Landscape Referral Response

Application Number:	DA2025/0265
Date:	10/04/2025
Proposed Development:	Demolition works and construction of a dwelling house including a swimming pool
Responsible Officer:	Kye Miles
Land to be developed (Address):	Lot 15 DP 14433 , 231 Alfred Street CROMER NSW 2099

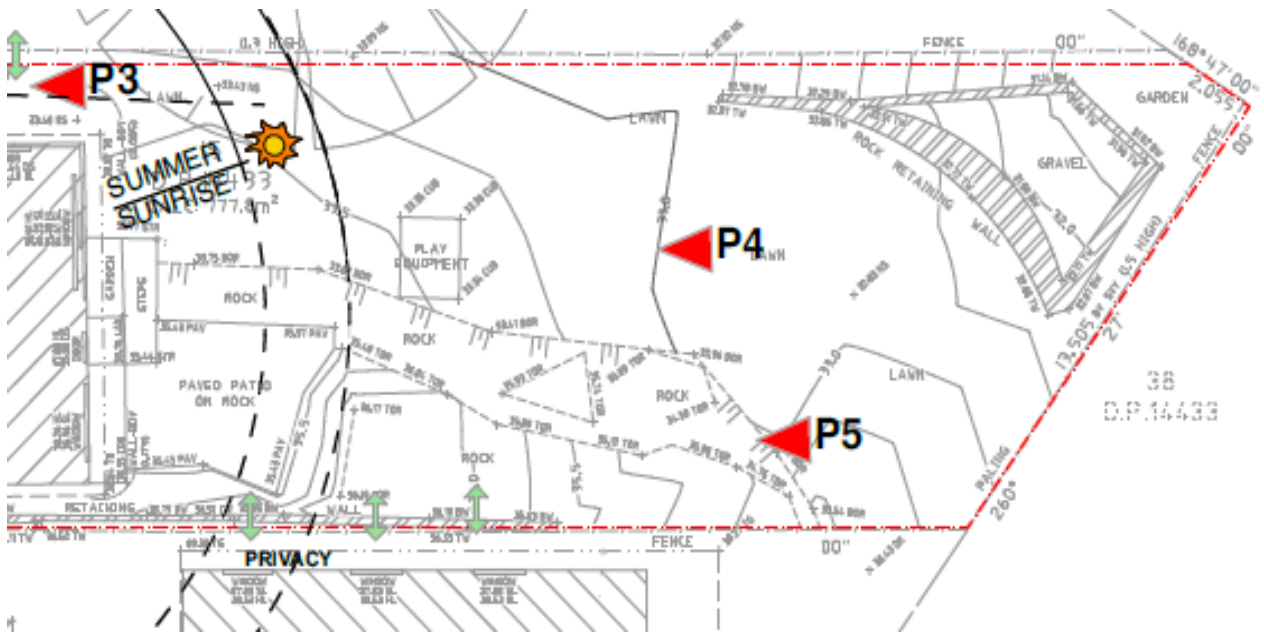
The Survey Plan indicates that a rock outcrop runs along the south western boundary in the rear yard. The outcrop is noted on the Site Analysis Plan.

The Architectural Plans indicate that the new dwelling is located largely above the rock outcrop, with a small section only requiring removal.

Review of the Survey Plan levels and Ground Floor level indicates that some localised levelling at the top the rock will likely be required.

It is apparent that the intent is to retain the majority of the rock outcrop in the rear yard.

Given the size of the outcrop, it may be advisable to seek comment from the AHO regarding potential for sites of significance.

From a landscape perspective, the retention of the majority of the rock is supported.

All rock outcrops outside of and below the area of approved works (i.e below the new dwelling) are to be preserved and protected at all times during demolition excavation and construction works. Minor levelling at the top of the rock may be undertaken to achieve approved ground floor levels if required.
